## V2500-A1 SERIES PROPULSION SYSTEMS SERVICE BULLETIN

This document transmits Revision 3 to Service Bulletin EV2500-72-0233

Reason for change  
To change instructions  
disposition from (2D) to  
(1D) and add instructions  
disposition (A) to reflect  
change in availability of  
parts 6A6435 and 6A6437

MODIFICATION SERVICE BULLETIN – ENGINE – LP COMPRESSOR – ROD ADJUSTMENT FEATURE  
RELOCATION OF LPC BLEED RIGGING

Fig.3 After Alteration of the Right Rod Assembly of  
LPC Bleed Valve

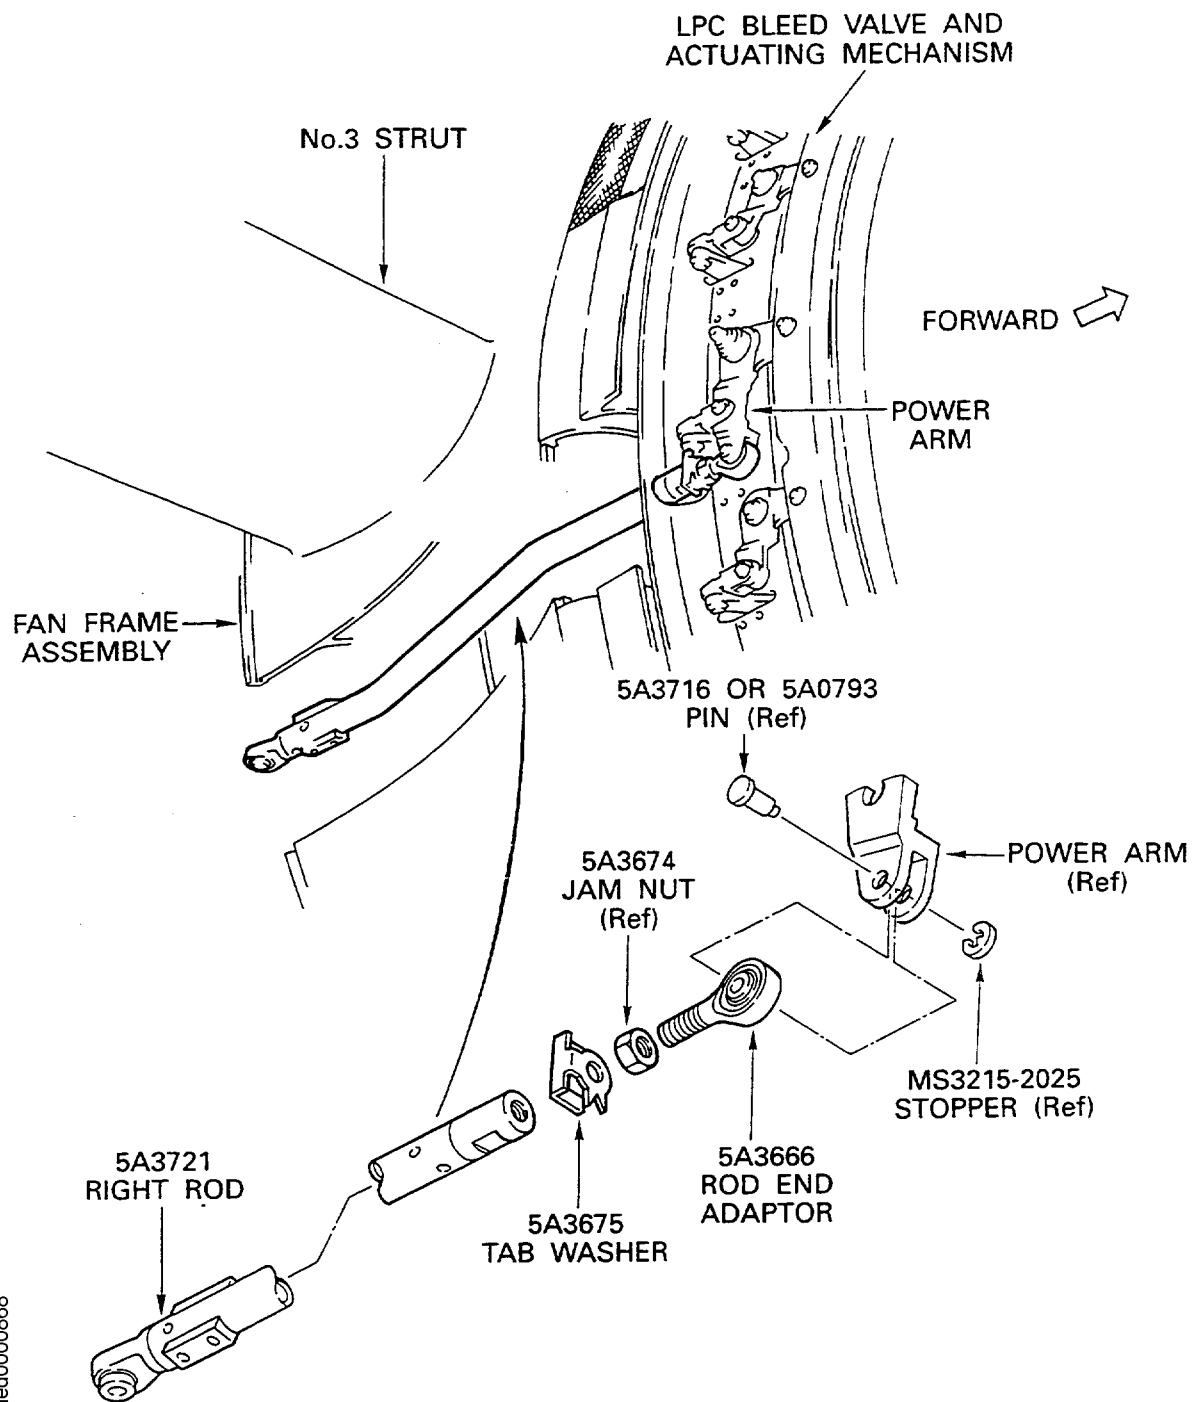
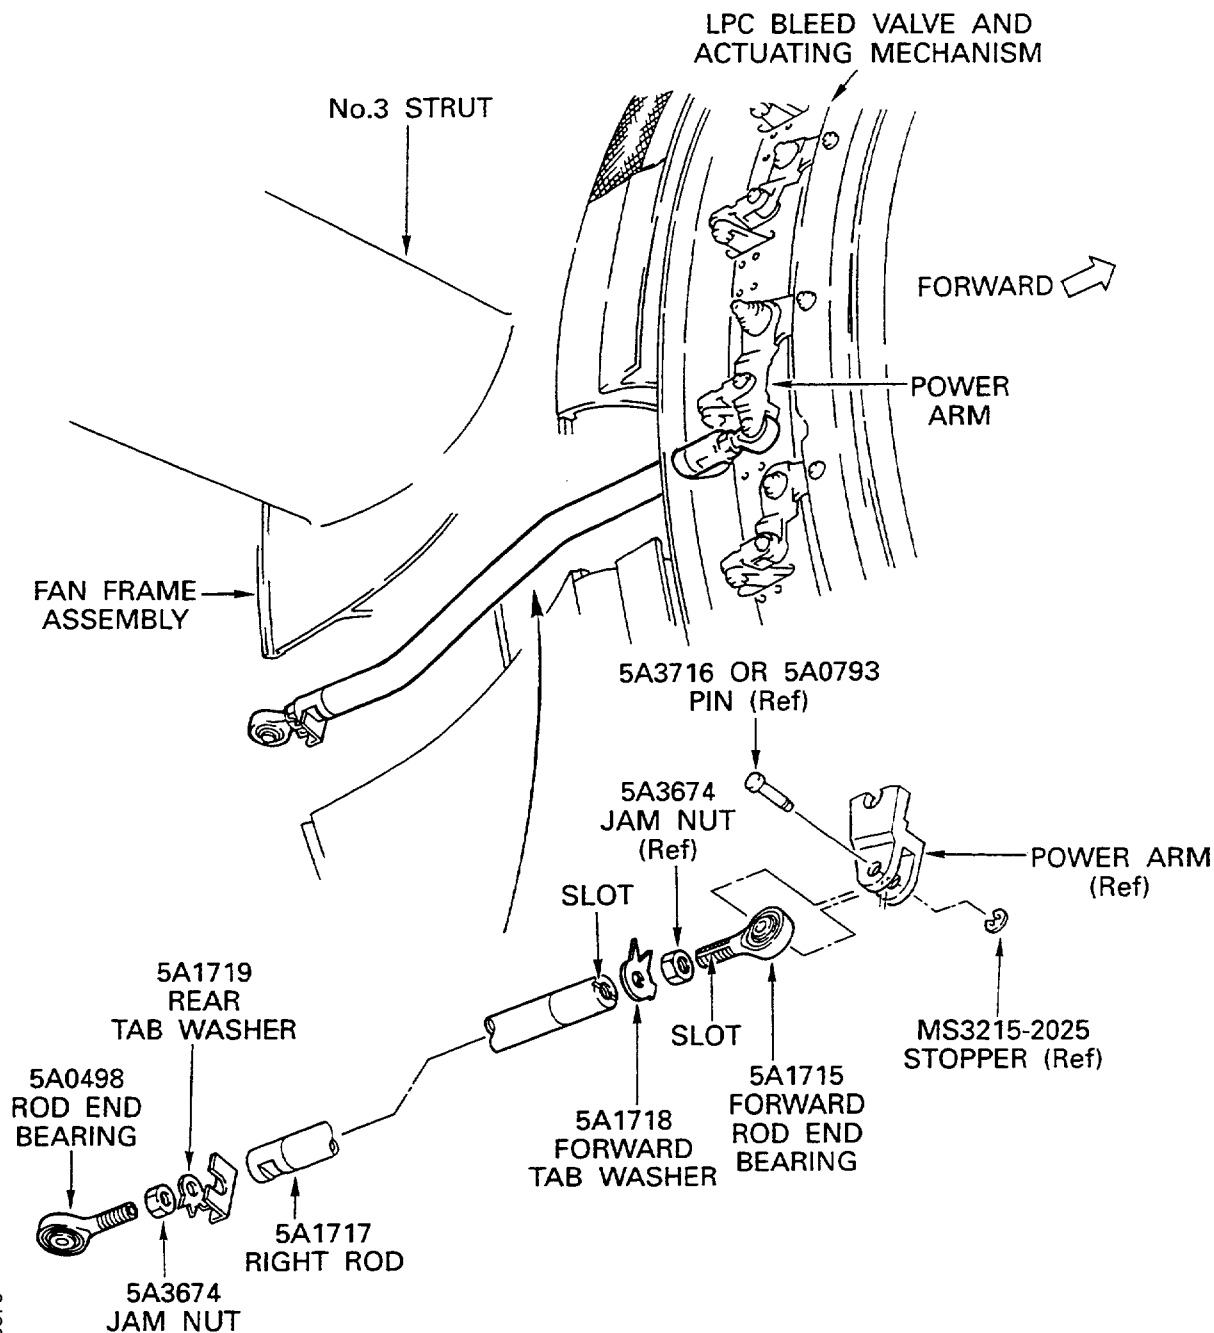
- (1) The change introduced by this Service Bulletin are as follows:
  - (a) To change the adjustment position of LPC Bleed Mechanism from forward end to rear end of Rod Assembly.

Rework of existing guide plates  
Fig 5

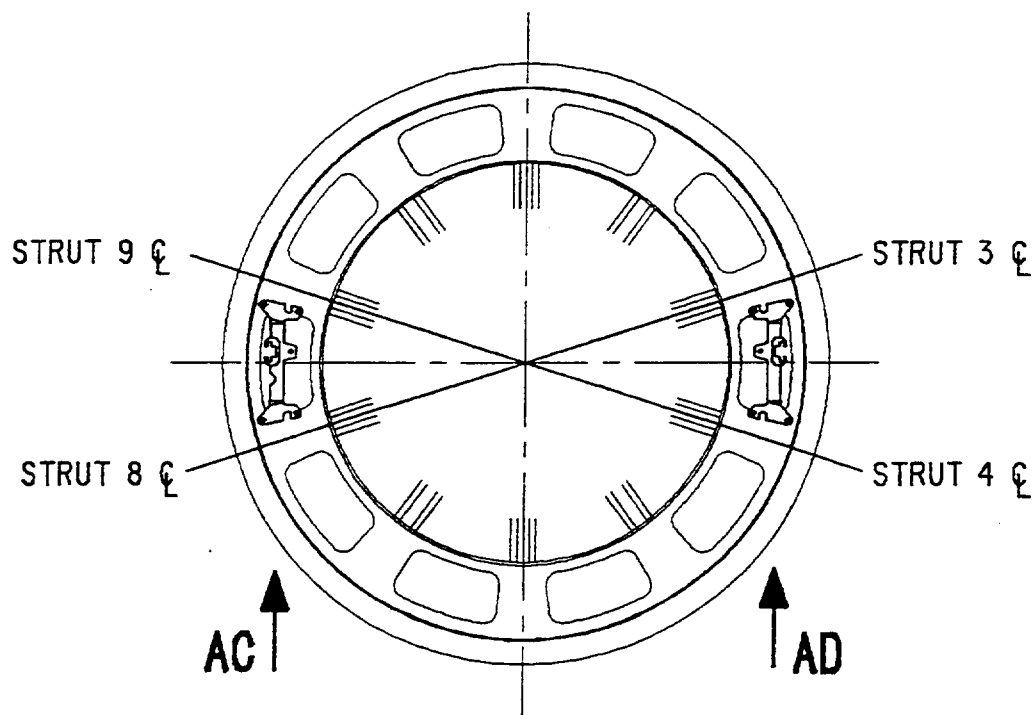
| (b) Mark off the area of the Guide, A/O BSBVA Master, that is to be removed. | See Fig 5, 6, 7, 8 and 9. Use standard workshop equipment.           |

Rework of existing guide plates  
Fig 8

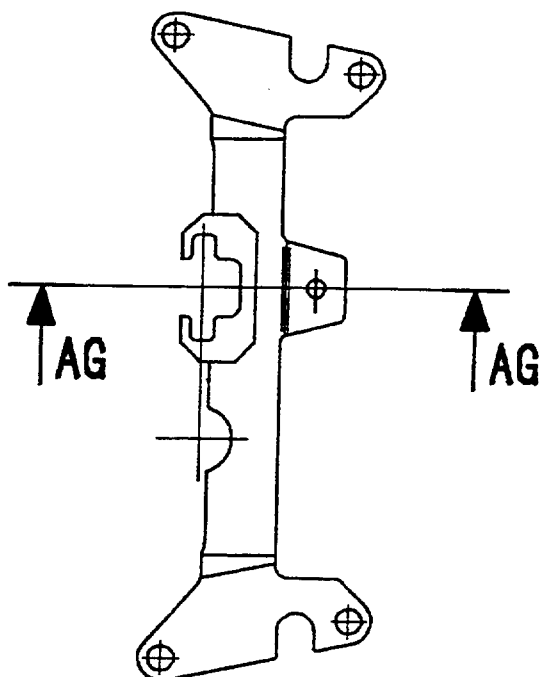
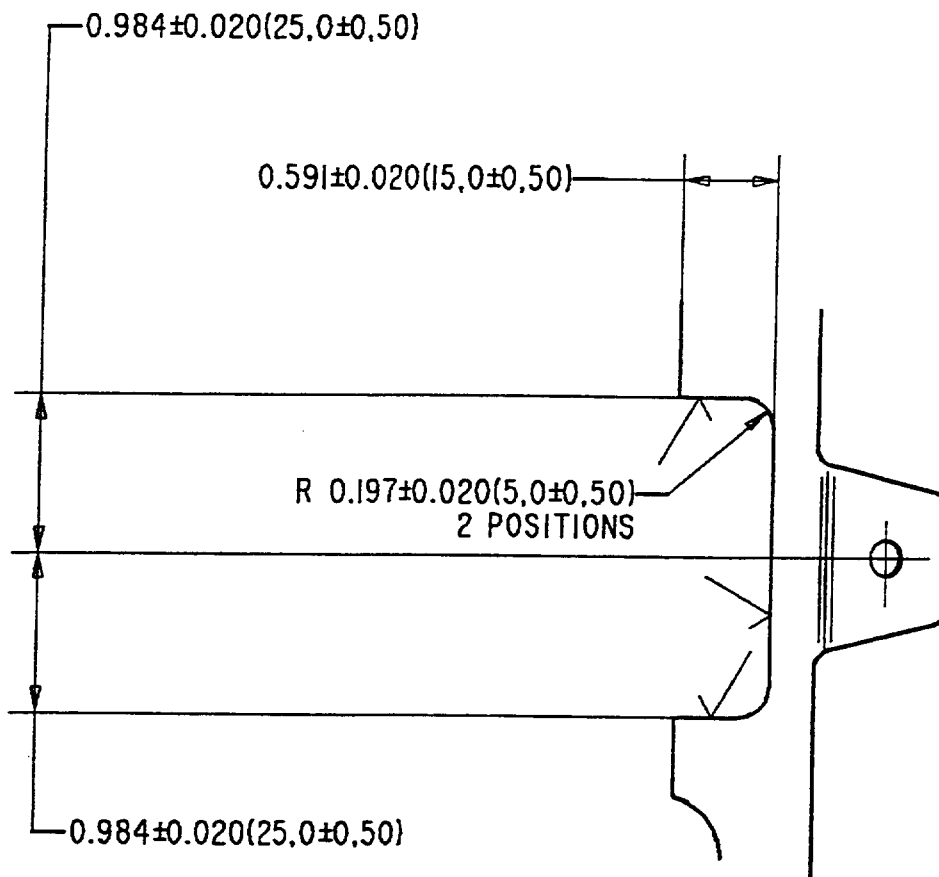
| (c) Rework the Guide, A/O BSBVA Master, in the area shown.                   | See Fig 8 and 9. Use standard workshop equipment.                    |
| (d) Remove sharp edges.  | See Fig 8 and 9. Use standard workshop equipment.                    |

Rework of existing guide plates  
Fig 10

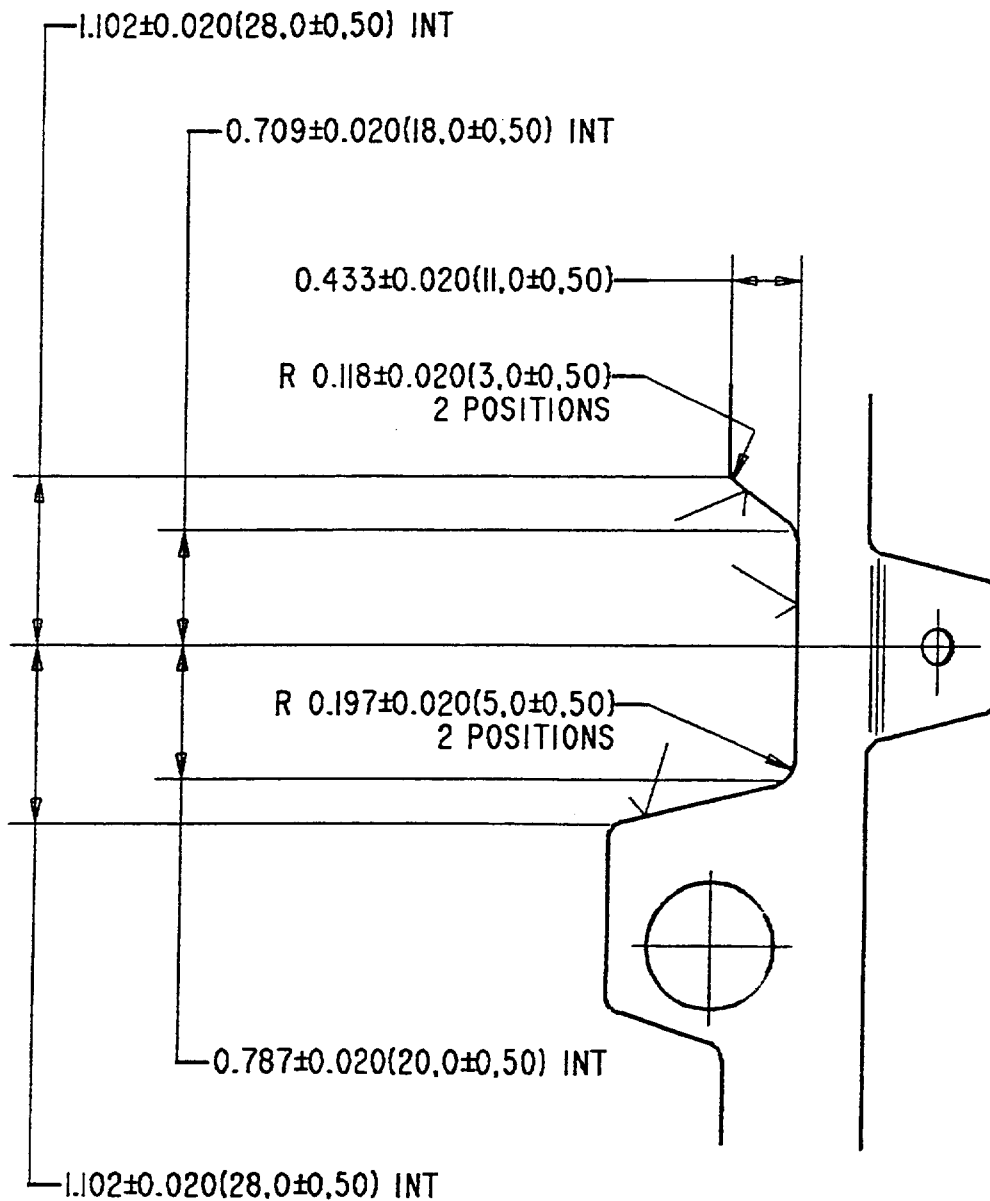
(c) Rework the Guide, A/O BSBVA Master, in the area shown.	See Fig 10 and 11. Use standard workshop equipment.
(d) Remove sharp edges.	See Fig 10 and 11. Use standard workshop equipment.

Rework of existing guide plates  
Fig 12

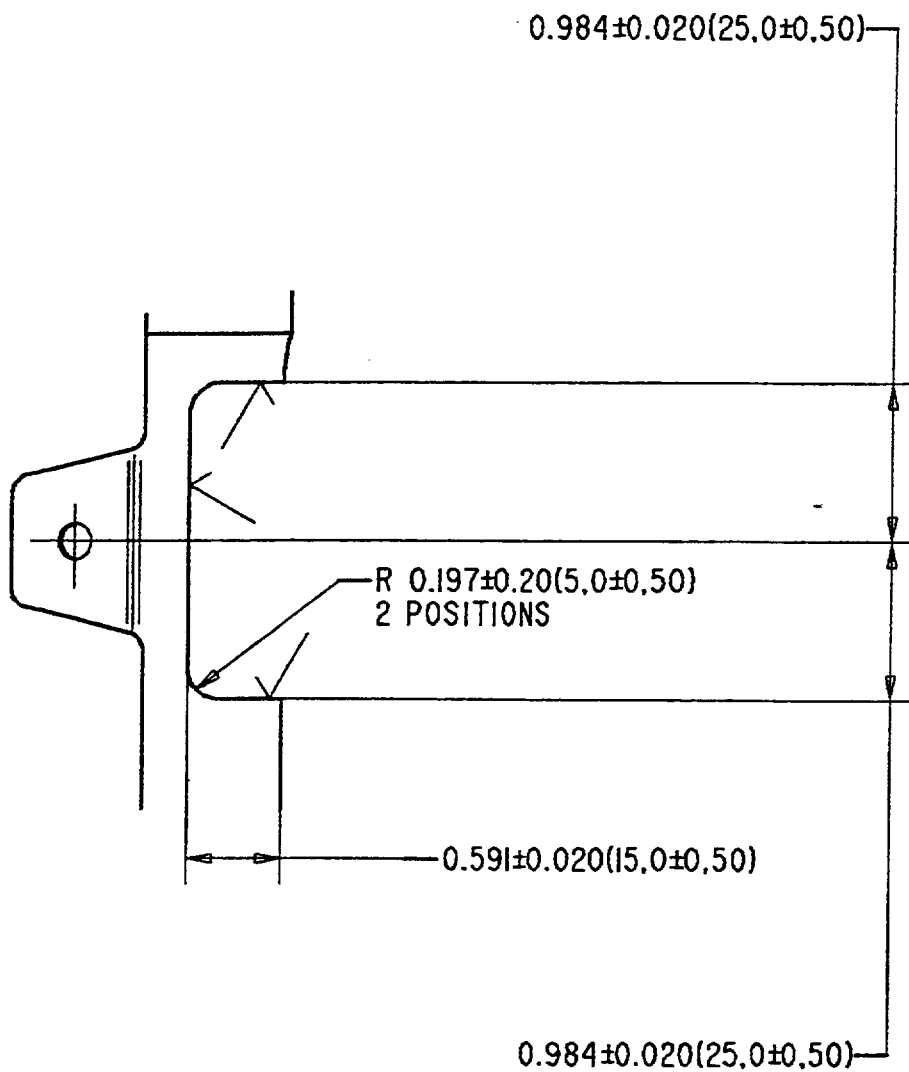
| (c) Rework the Guide, A/O BSBVA Slave, in the area shown.                   | See Fig 12 and 13. Use standard workshop equipment.  |
| (d) Remove sharp edges.   | See Fig 12 and 13. Use standard workshop equipment.  |

Rework of existing guide plates  
Fig 14

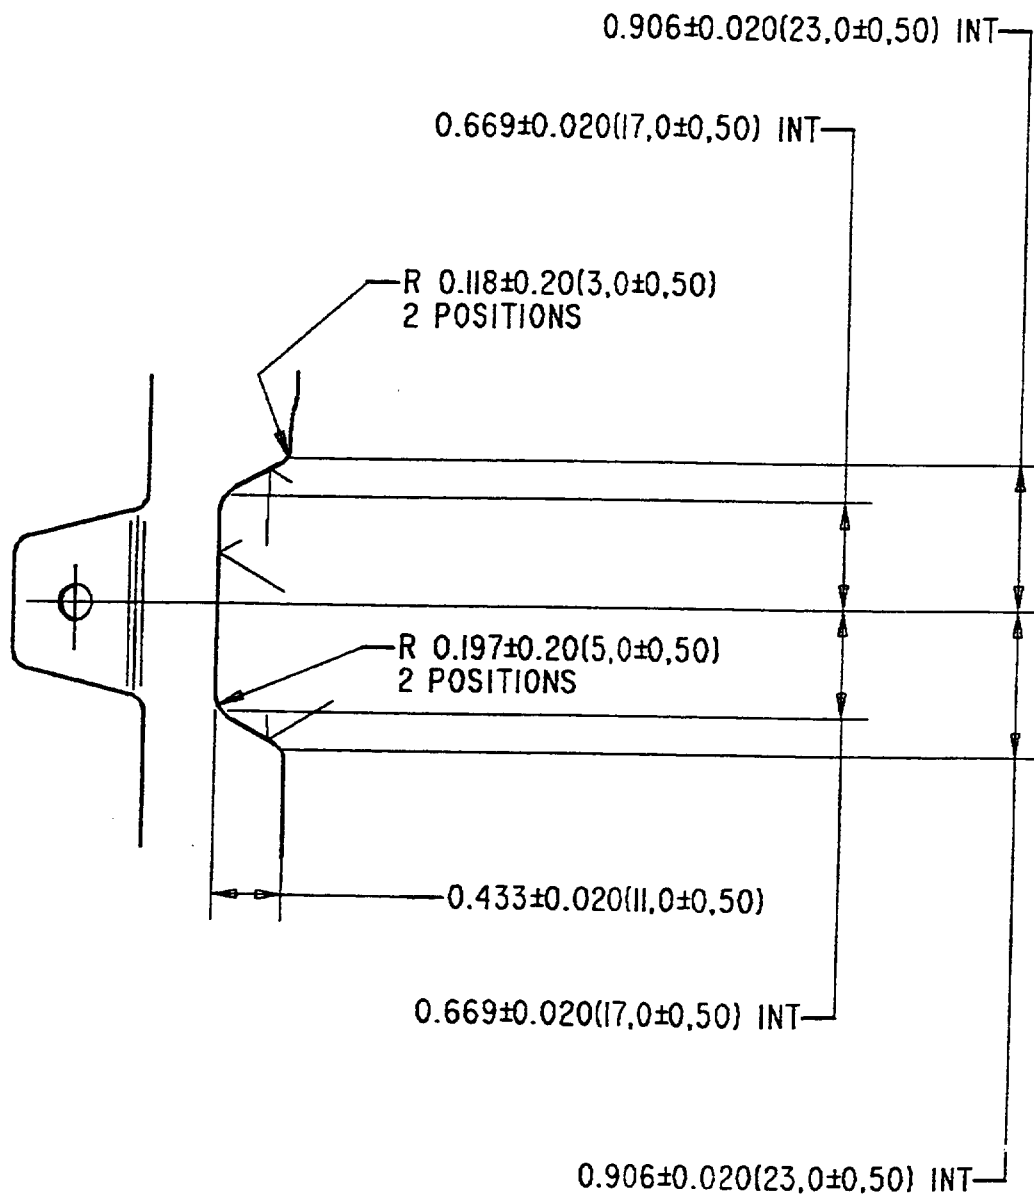
- (b) Mark off the area of the Guide, A/O BSBVA Slave, that is to be removed. See Fig 5, 6, 7, 14 and 15. Use standard workshop equipment.
- (c) Rework the Guide, A/O BSBVA Slave, in the area shown. See Fig 14 and 15. Use standard workshop equipment.

- (d) Remove sharp edges. See Fig 14 and 15. Use standard workshop equipment.
- (e) Chemical clean the Guide, A/O BSBVA Slave. Refer to SPM TASK 70-11-03-300-503. Use chemical cleaning equipment.
